U. S. EPR Standard Design Certification

Docket No. 52-020

SRP Section: 09.02.02 - Reactor Auxiliary Cooling Water Systems

09.02.02-114

Figure 9.2.2-2—Component Cooling Water System Common Loop 1
Sheet 7 of 7

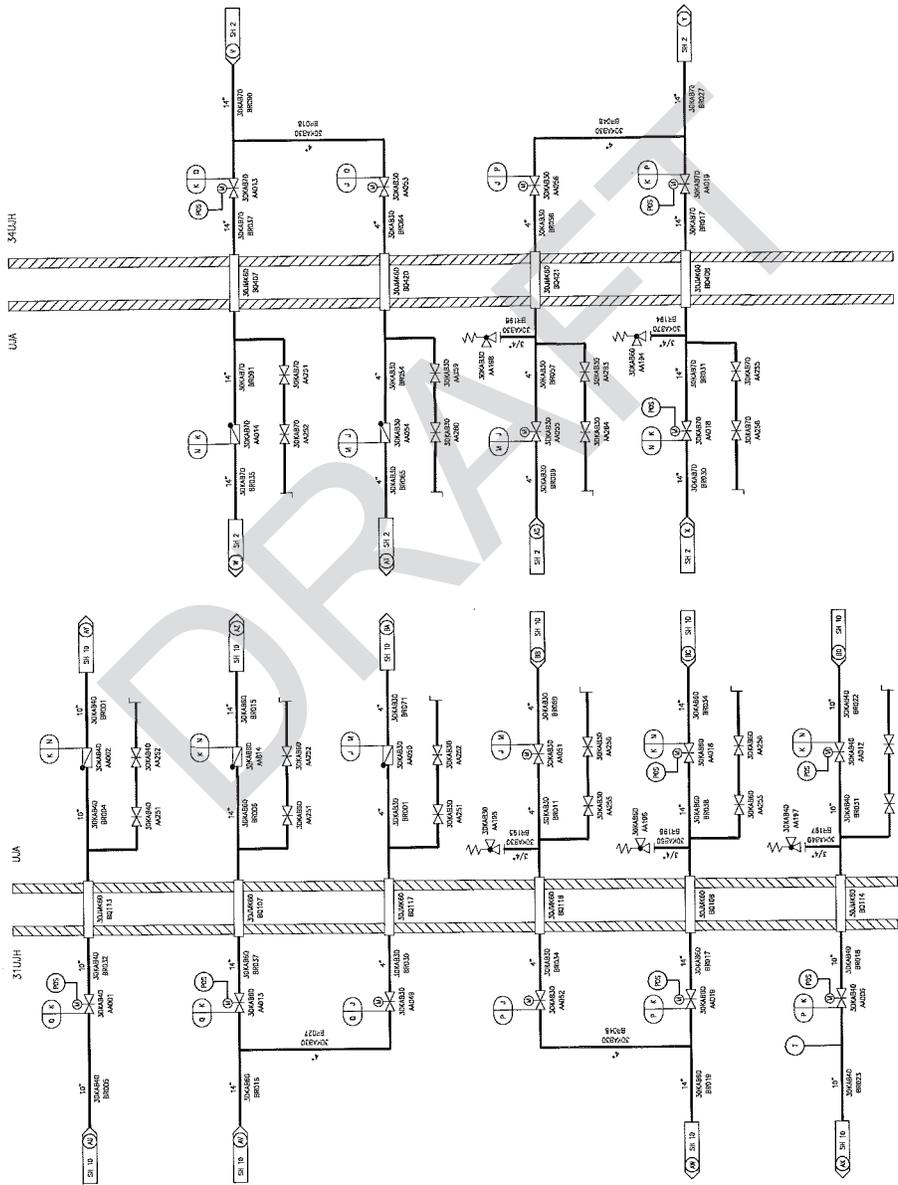
containment isolation valves (CIVs) in the RCP thermal barrier cooling path on the supply and return side of CCWS common 1b cannot be opened unless the CIVs on both the supply and return side of common 2b are closed and vice-versa.

The CCWS piping, valves and components supplying the RCP thermal barriers is Seismic Category I, Quality Group C, ASME III Class 3 with the exception of the CIVs and the piping between the CIVs, which are Seismic Category I, Quality Group B, ASME III Class 2.

U.S. EPR FSAR Tier 2, Sections 9.2.2 and 14.2 and Tier 1 Section 2.7.1 will be revised as described in the response and indicated on the enclosed markup.

Figure 2.7.1.1—Component Cooling Water System Functional Arrangement
Sheet 7 of 11

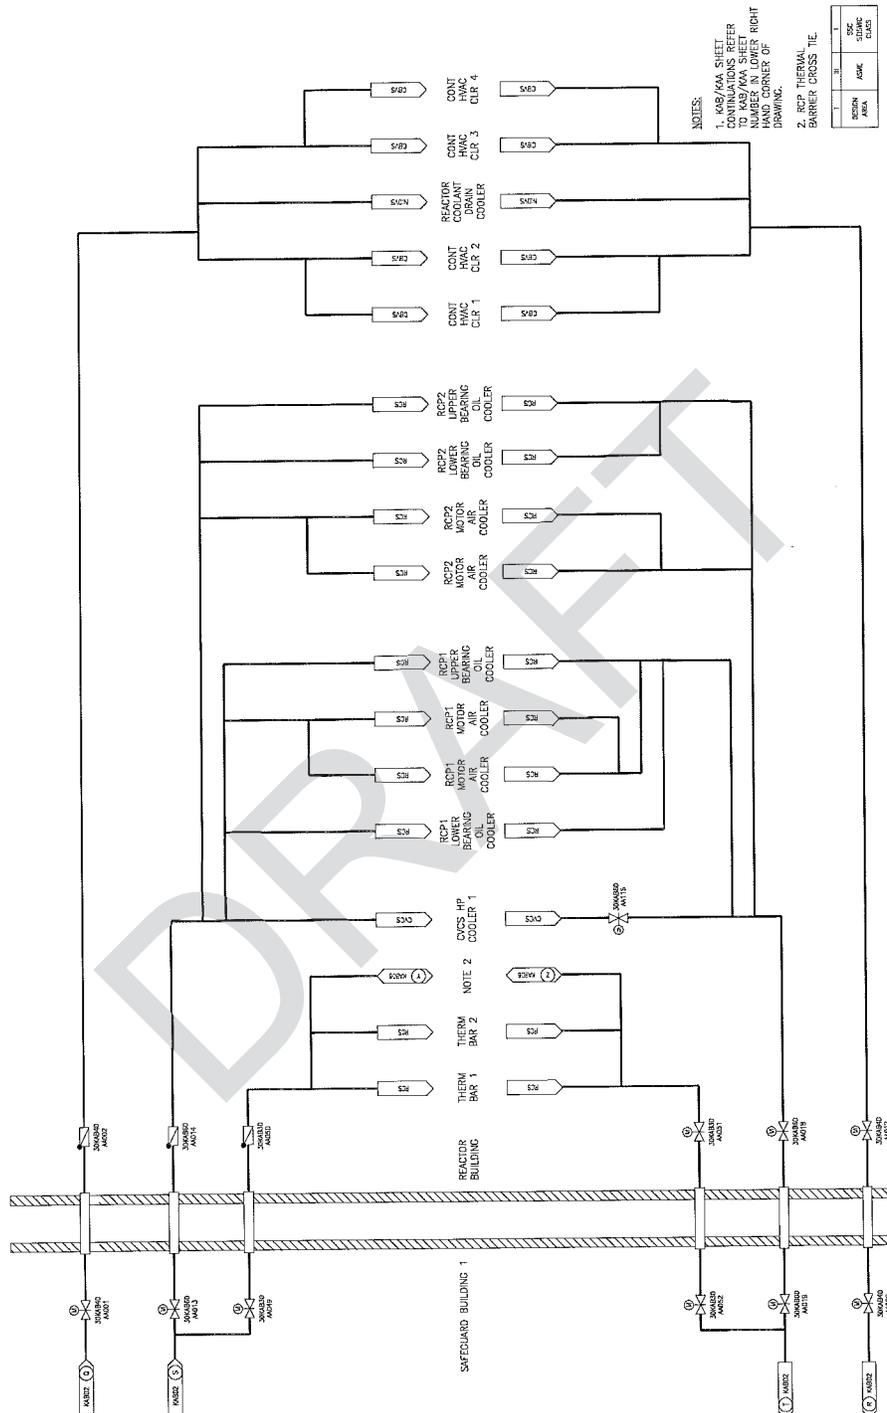
NOTES:
 1. K&E/AAA SHEET CONTINUATIONS REFER TO SHEET NUMBER IN LOWER RIGHT HAND CORNER OF DRAWING.
 2. RCP THERMAL BARRIER CROSS TIE.

Figure 9.2.2-2—Component Cooling Water System Common Loop 1
Sheet 7 of 7

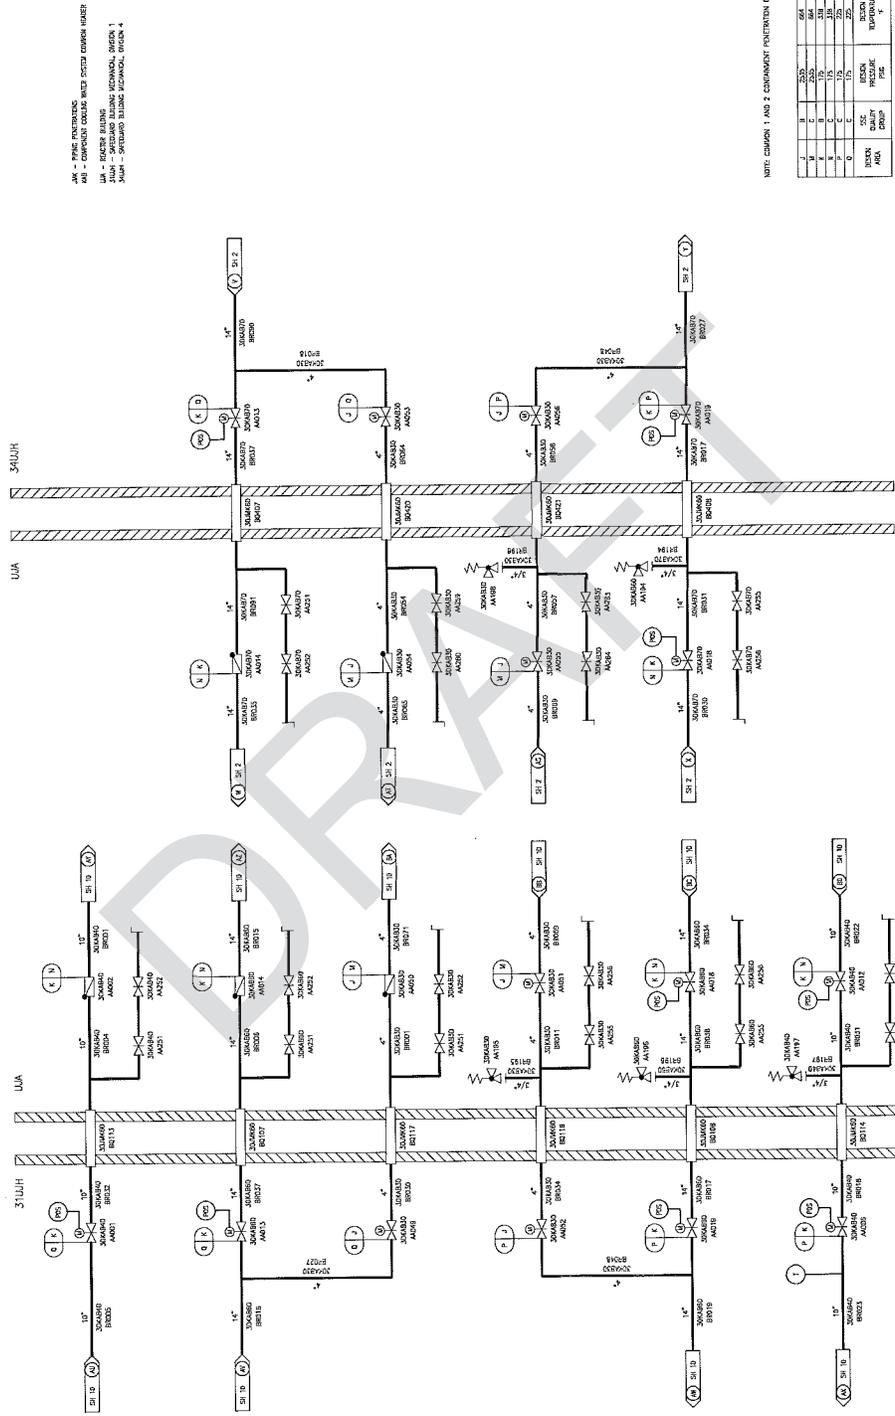
The non-safety-related CCWS loads in the NAB and RWB can be quickly isolated from the rest of the CCWS by fast-closing hydraulic valves, as required. The non-safety-related common branches of the CCWS trains are shown in Figure 9.2.2-2—Component Cooling Water System Common Loop 1, and Figure 9.2.2-3—Component Cooling Water System Common Loop 2.

U.S. EPR FSAR Tier 2, Sections 9.2.2 and 14.2 and Tier 1 Section 2.7.1 will be revised as described in the response and indicated on the enclosed markup.
